Roads & Bridges Committee
NOTICE OF SPECIAL MEETING

Re: Enbridge Pipeline Maintenance
Traffic Control & Haul Route Review

Re: 2016 Bridge Inspections

Re: Cuba Road Bridge (Structure No. 049-6051)
Village of Barrington Hills
WJE No. 2015.5885

Figure 5. Area of repaired concrete on the soffit (east cell) showing indications of moisture staining through the joint.

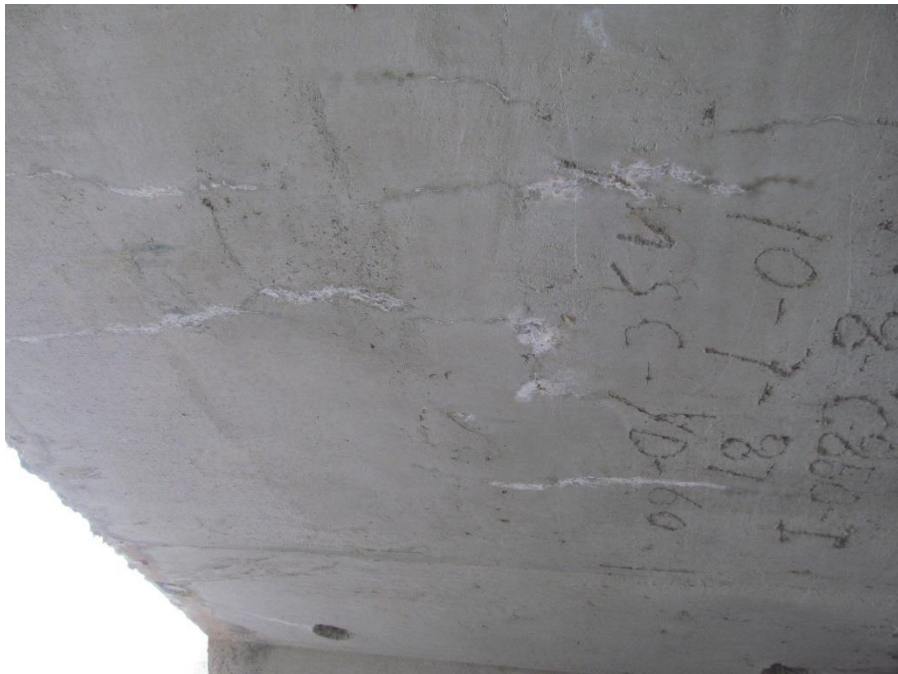
Overall the culvert structure was observed to be in satisfactory condition, which corresponds to a condition rating of 6 for *Item 62: Culvert Condition*. The concrete boxes exhibit some minor concrete deterioration including freeze-thaw cracking and efflorescence at the headwalls (Figure 4) and moisture staining and efflorescence present at various joints on the interior of the culvert. Cracked joint sealant was typically observed between cells, and some joints contained failed seals. Areas of concrete repair (performed in 2014) were also inspected and appear to be performing well (Figure 5). It should be noted that the repair area shown in Figure 5 has moisture staining and light efflorescence on the surface of the repair material, indicating that moisture is penetrating the asphalt wearing surface and making its way through the adjacent joint in the precast boxes. The soffit of the precast boxes exhibit isolated areas of cracking with

Figure 8. Overall view of the asphalt roadway (facing southeast) showing a depressed area of asphalt pavement (red arrow) and the surrounding cracking (green arrows).

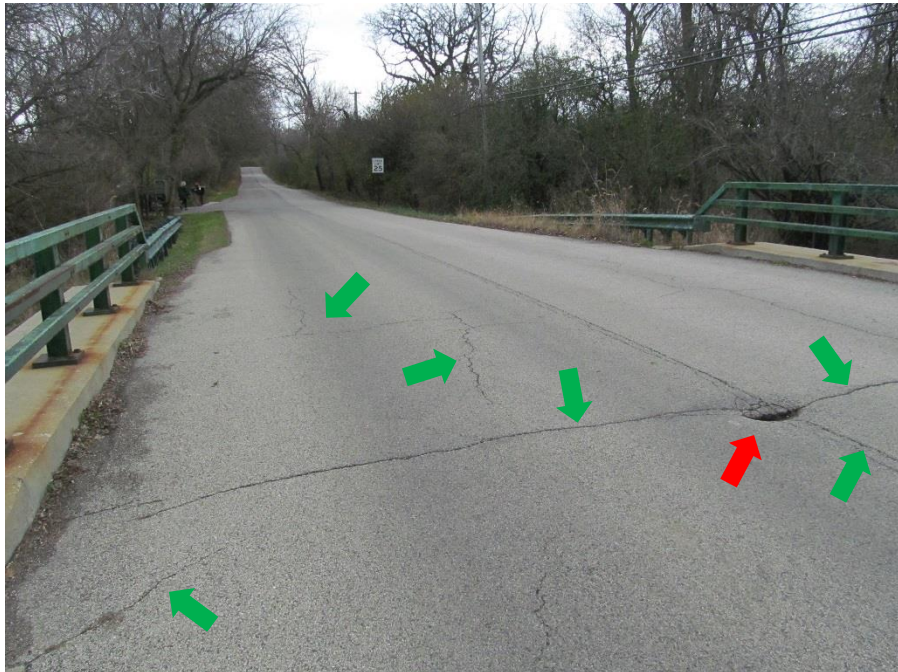
The asphalt roadway is in fair condition overall. One small depression, approximately 1 square foot in size, was observed at the roadway centerline over the northwest end of the culvert structure (Figure 8). In addition, longitudinal and transverse cracking of the asphalt surface (Figure 8) has increased since the 2012 inspection.
